STATE OF HAWAII
DEPARTMENT OF TRANSPORTATION
HIGHWAYS DIVISION

ADDENDUM NO. 2

**INTERSTATE ROUTE H-1 ADDITION AND MODIFICATION OF FREEWAY ACCESS
(KAPOLEI INTERCHANGE COMPLEX), PHASE 3**

FEDERAL-AID PROJECT NO. NH-H1-1(271)

Modified Type 61614P Drain Inlet I-2
Scale: 1/2"= 1'-0"

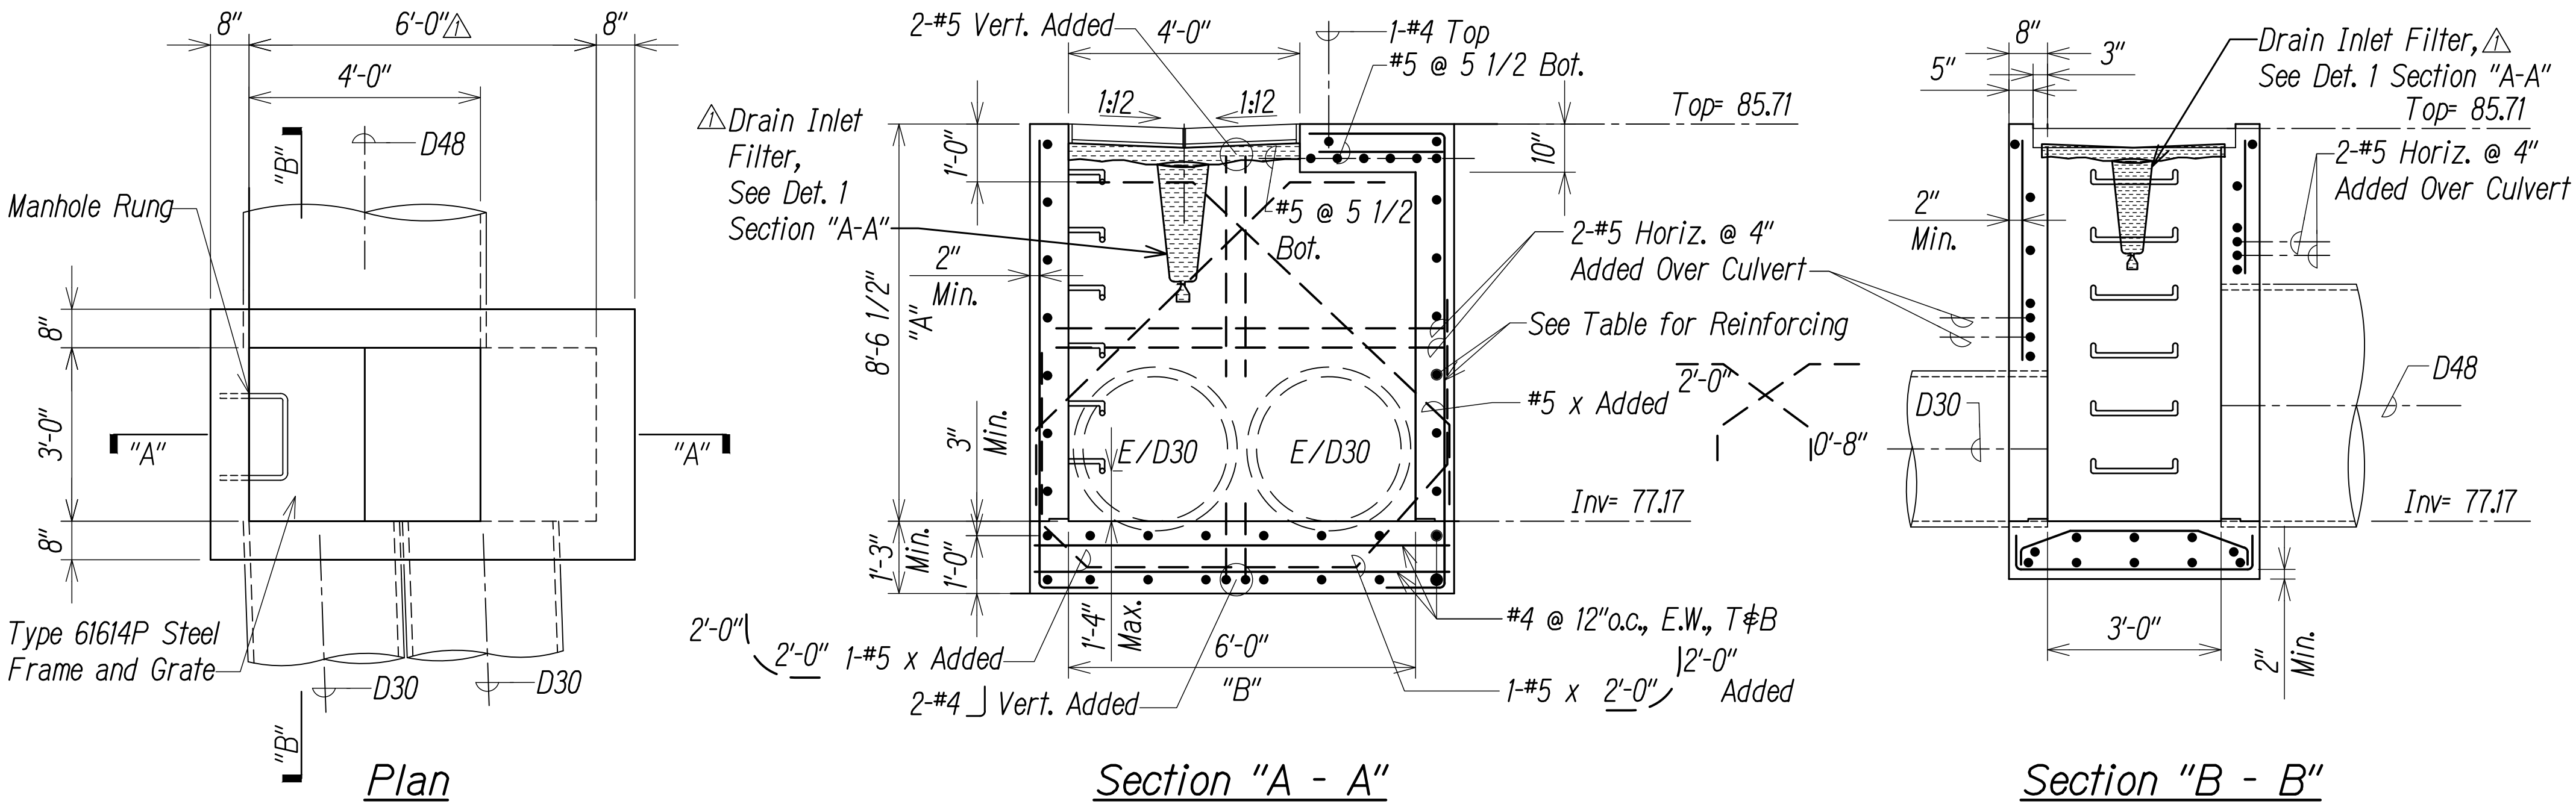
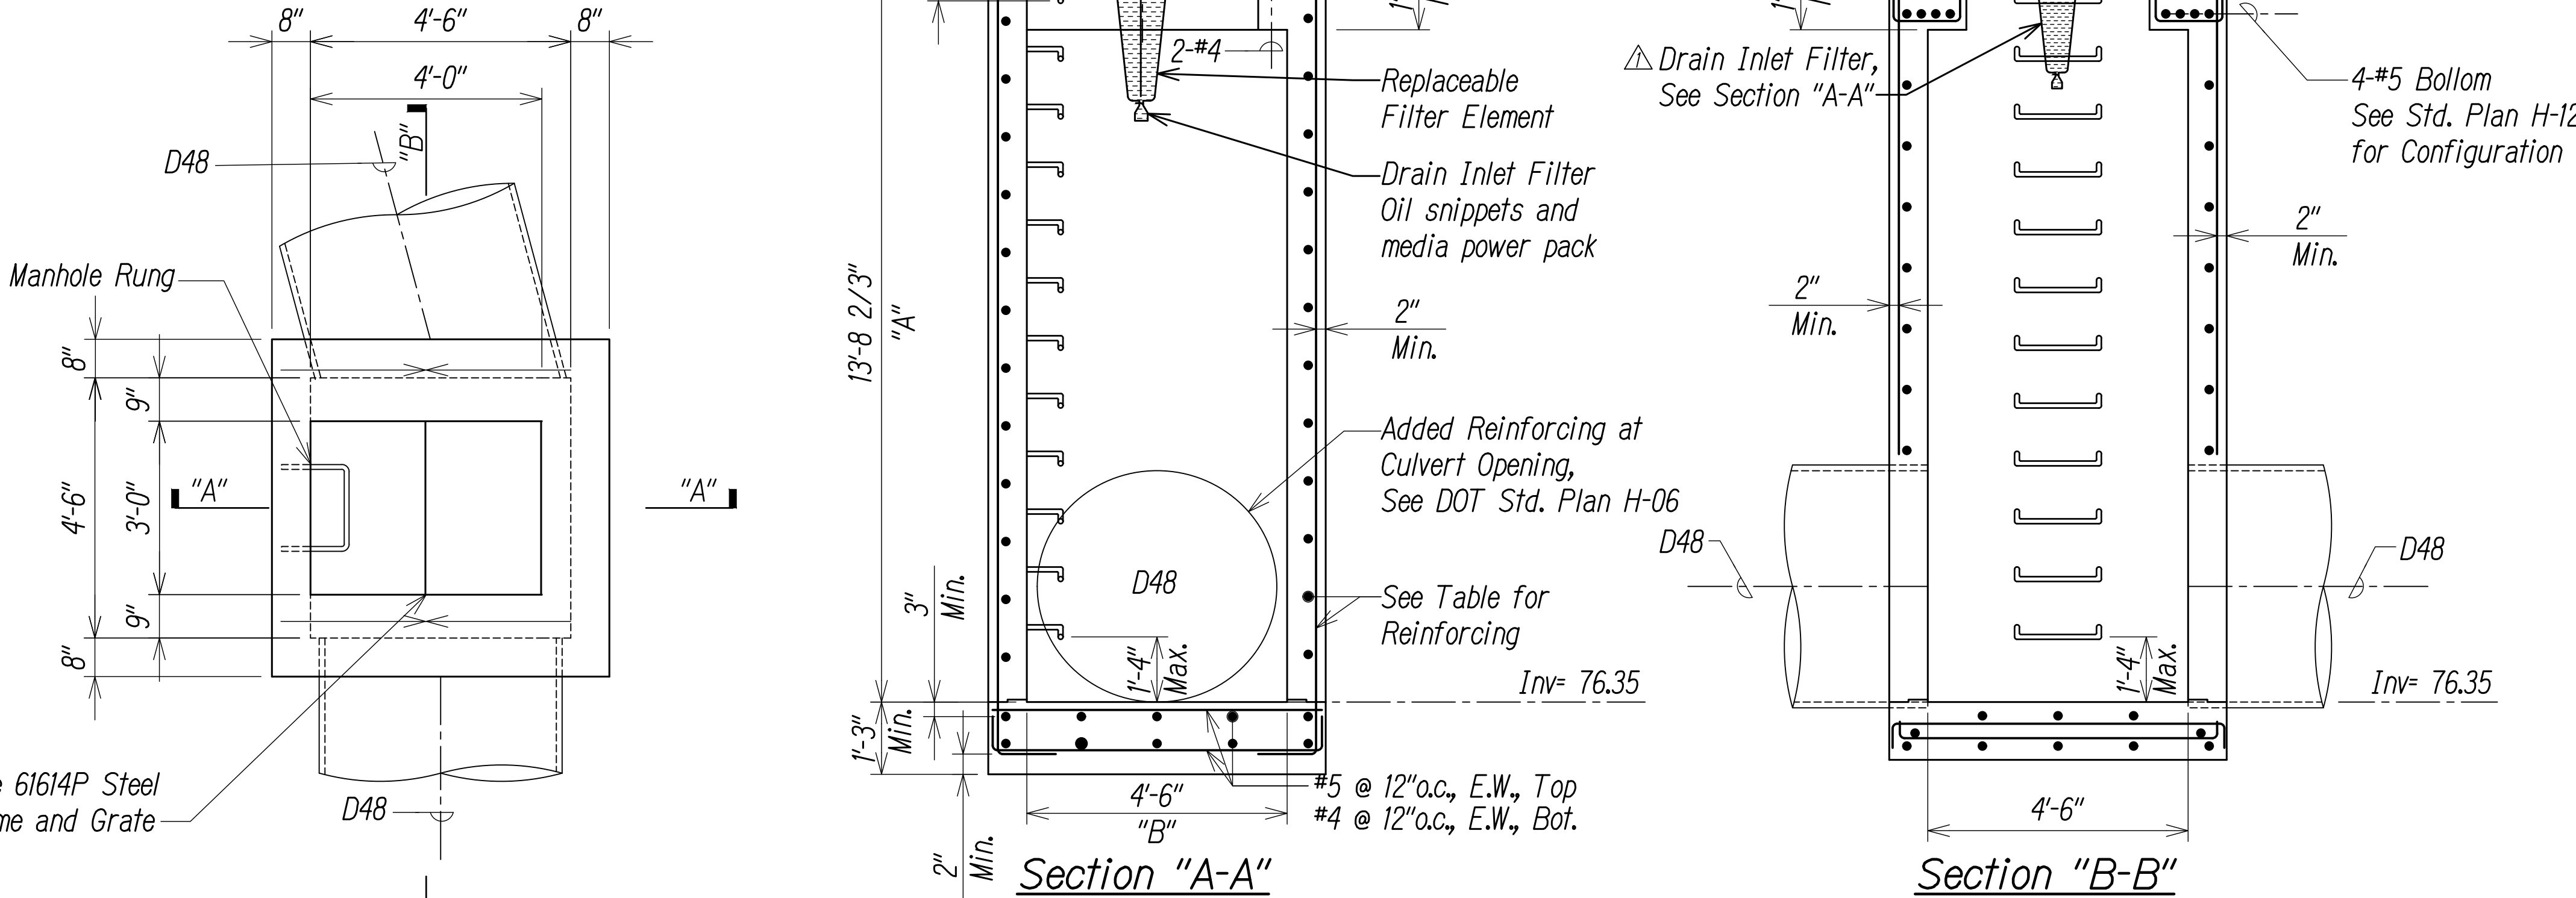
10/21/2022	Added drain inlet filter, revised width to 6'-0"
DATE	REVISION
STATE OF HAWAII DEPARTMENT OF TRANSPORTATION HIGHWAYS DIVISION	
DRAINAGE DETAILS 4	
INTERSTATE ROUTE H-1 ADDITION AND MODIFICATION OF FREEWAY ACCESS (Kapolei Interchange Complex), Phase 3 Federal Aid Project No. NH-H1-K(271)	
Scale: As Noted	Date: August 2022
